POLICY REPORT  
DEVELOPMENT AND BUILDING

Report Date: February 17, 2015  
Contact: Susan Haid  
Contact No.: 604.871.6431  
RTS No.: 10854  
VanRIMS No.: 08-2000-20  
Meeting Date: March 3, 2015

SUBJECT: CD-1 Rezoning - 126, 136, 146, 156, 166 and 168 East 35th Avenue

Figure 2: Site Plan

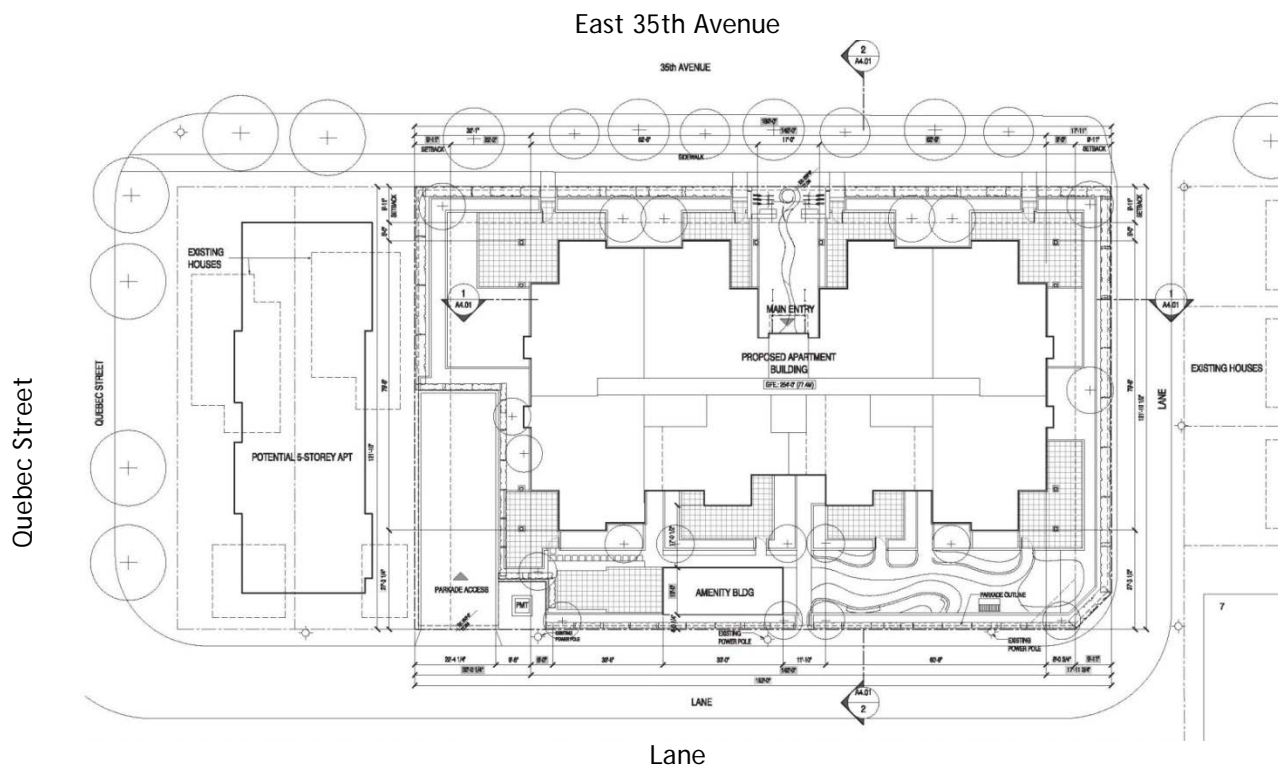
- 1. Design Development to provide a clear delineation between private and public space at the ground level.

Note to Applicant: The ground plane of the building should rise a minimum of 12" to provide separation between ground level units and public space.
- 2. Design development to improve the legibility of the amenity building at the rear of the property to ensure both a direct connection with the main building and a positive relation to the lane.

24. Clarify garbage pick-up operations. Please provide written confirmation that a waste hauler can access and pick up from the location shown. Note; pick up operations should not rely on bins being stored on the street or lane for pick up, bins are to be returned to storage areas immediately after emptying. An on-site at-grade storage pad is recommended.

26. Provision of details of the column placement within the underground parking in compliance with the requirements of the Engineering Parking and Loading Design Supplement.
27. Provision of parking spaces sized and labelled in imperial measurement to agree with the drawing scale.
28. Provision of bicycle rooms not to contain more than 40 bicycle spaces unless the spaces in excess of 40 are bicycle lockers.

29. Provision of confirmation that the vertical bicycle spaces are situated adjacent a wall.

Note to Applicant: bicycles placed vertically are not to be hung from the ceiling, but rather leaned up against a wall, and this does not appear possible.

30. Relocate the two "dead end" small car parking spaces so that they are accessible via a standard manoeuvring aisle or delete these spaces.

Note to Applicant: it is too far to back up and as shown requires too many turns to place the car in a forward direction.
